ENVIRONMENTAL REVIEW TEAM REPORT

HIGH MEADOWS SUBDIVISION ROXBURY, CONNECTICUT

MARCH 1979

FIGURE 1.

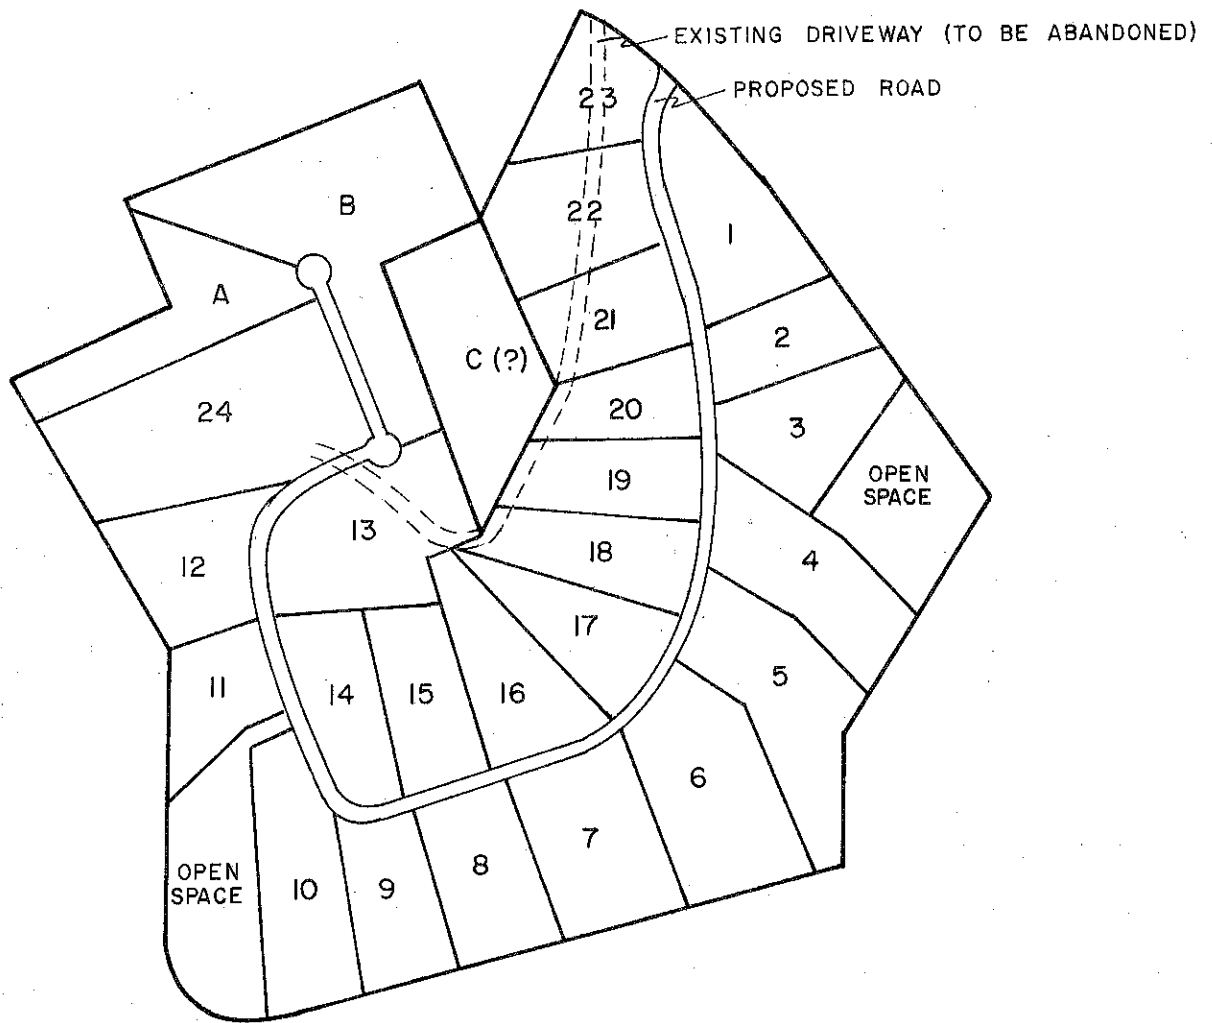
Two "open space" lots are being proposed under the conceptual plan to meet the requirements of the town's cluster subdivision regulations. Also as shown in Figure 1, the development would entail the construction of one new interior road off Route #67.

The applicant is utilizing the Interior Zone special permit provisions allowed in the Zoning Regulations. Under this provision, lots A and B are proposed as interior lots. The land locked parcel east of Lot B may become a third interior lot if negotiations by the applicant are successful. Each interior lot must have a minimum lot size of 4 acres.

The applicant is also proposing to use the Cluster Subdivision provision of the subdivision regulations for 17 lots. Under these provisions, the lot sizes may be reduced to 2.25 acres - land not allocated for lots and streets shall be set aside as permanent open space. The open space shall equal "a minimum of six acres or the same percentage of the entire tract by which the lot area has been reduced, whichever is greater...." The applicant has proposed to set aside 12 acres as open space. The open space may have to be enlarged slightly to 12.75 acres to meet the provisions of the cluster subdivision regulations.

The developer has proposed that 17 of the 24 standard lots be reduced in size from 3 to 2.25 acres under the cluster provisions of the subdivision regulations. This alternative would set aside approximately 12 acres as open space in the southwest and southeast corners of the project (see Figure 1). The southwest parcel preserves a wetlands corridor and steep slope areas on the western flank of Bronson Mountain. The southeast parcel is on an area of steep slopes adjacent to Route 67 and preservation of this parcel may help to protect a natural spring on the adjacent property.

FIGURE 2.

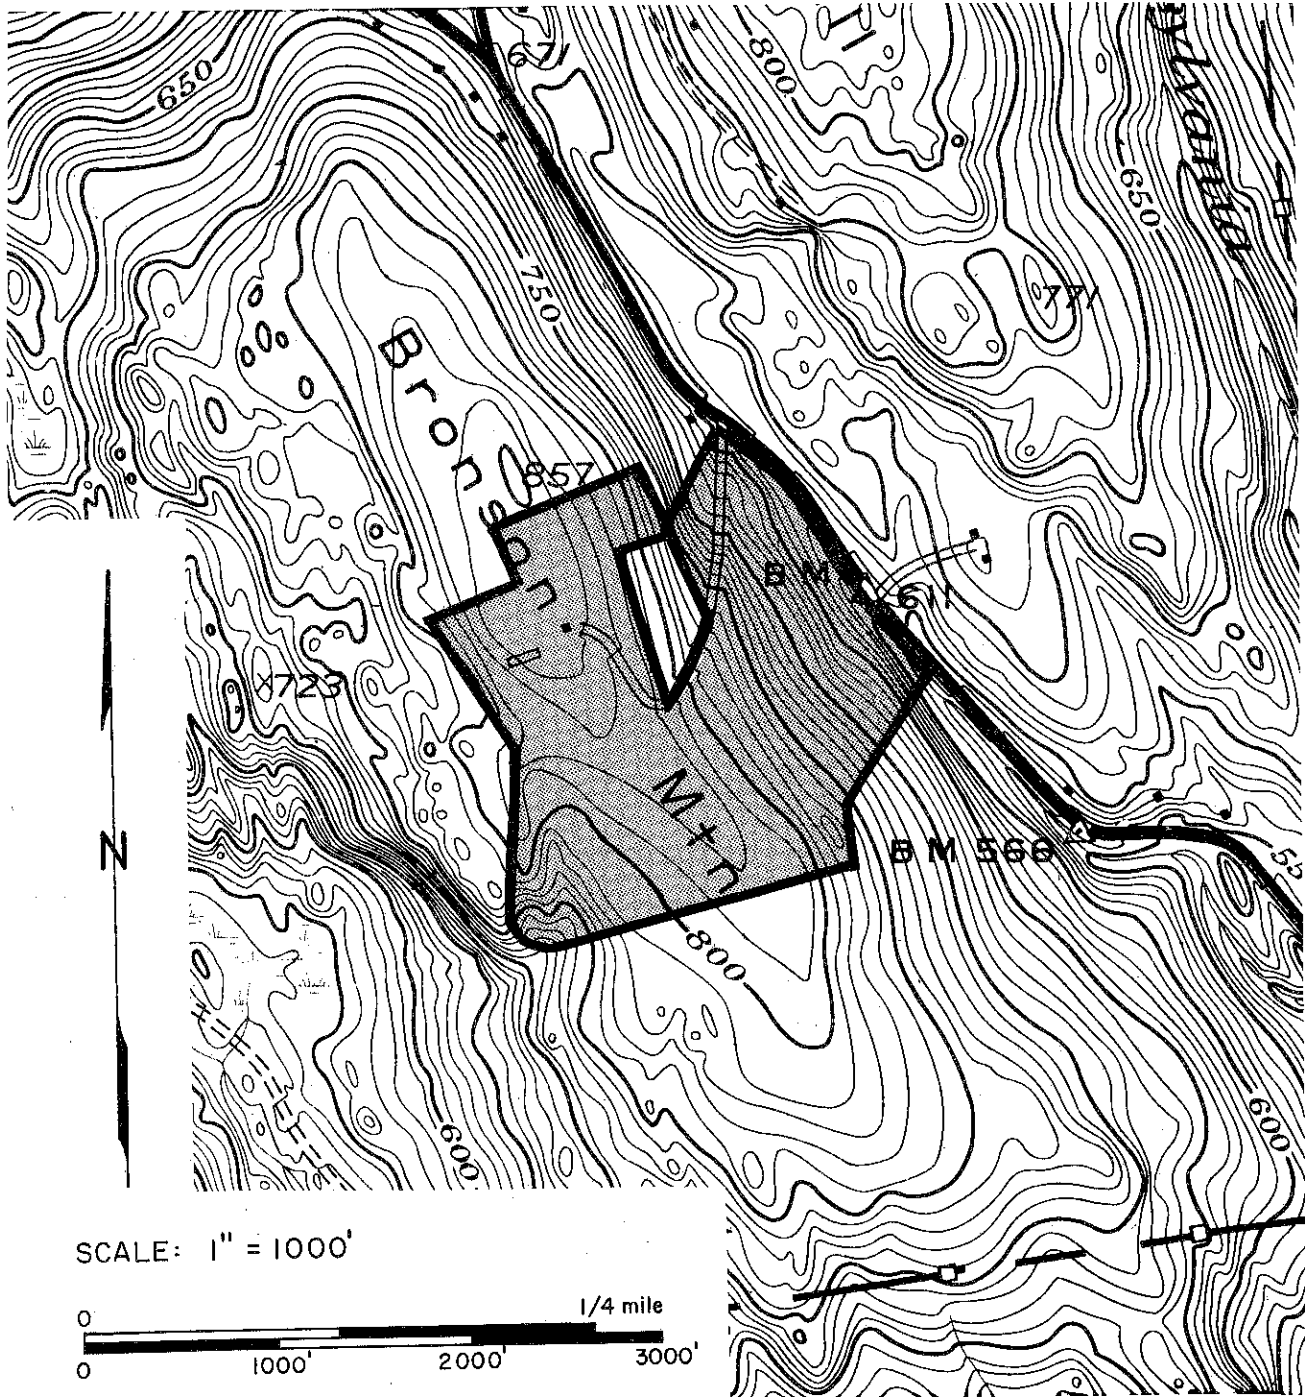
The subject property is located in southeastern Roxbury adjacent to Route 67 and approximately one mile northwest of the Roxbury/Woodbury town lines. The property includes the major portion of the eastern flank and the table land on the summit of Bronson Mountain (see Figure 2). Slopes on the eastern half of the property average approximately 16% with the property dropping more than two hundred feet from the summit of Bronson Mountain to Route 67. The western half of the site is nearly level.

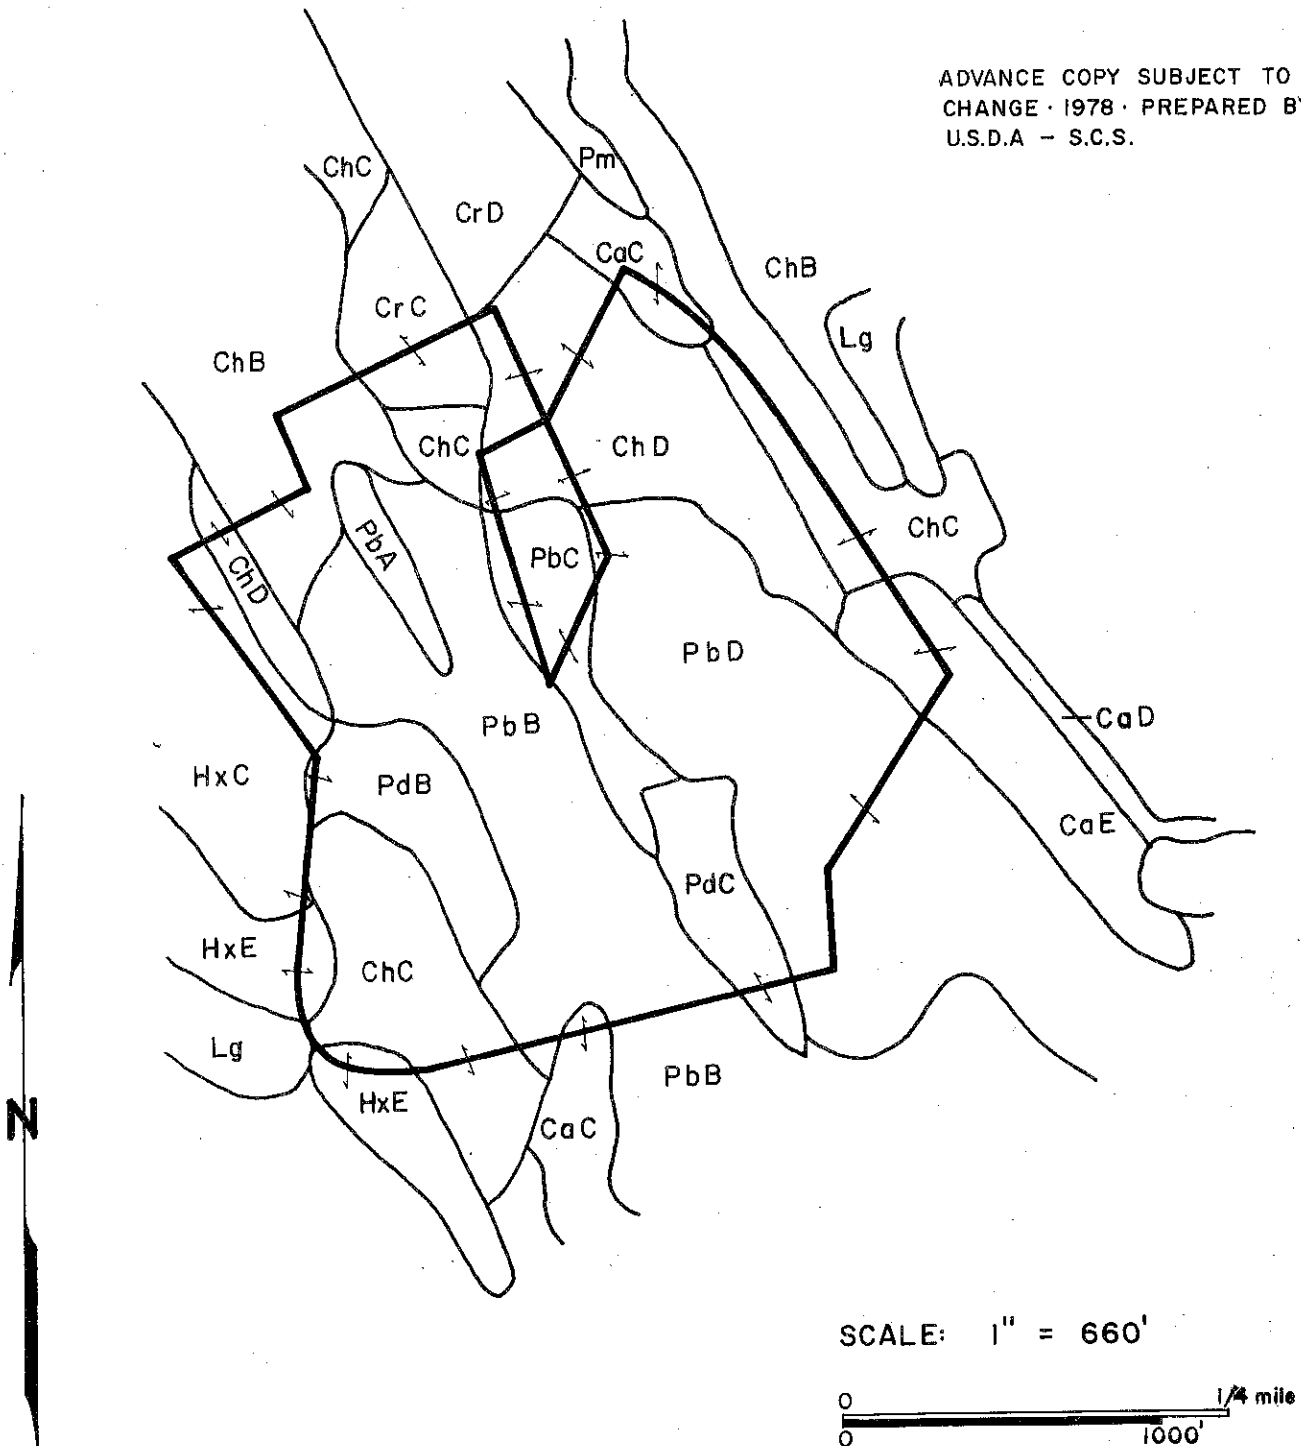
Given the soils and slope conditions of the property, consideration should be given to concentrating cluster development on the summit of Bronson Mountain and restricting or abandoning development along the steep eastern flank where soil conditions are not as favorable. This alternative would serve to preserve the visual integrity along the highway and offer greater protection of the wetlands corridor along Route 67. The feasibility of this alternative would of course depend upon results of soil testing performed in the area proposed for clustering. It should also be recognized that this alternative does represent a tradeoff as the aesthetic impact of this alternative would be greater on surrounding ridgelines (i.e. more homes on the summit would be visible from the adjacent ridgeline areas).
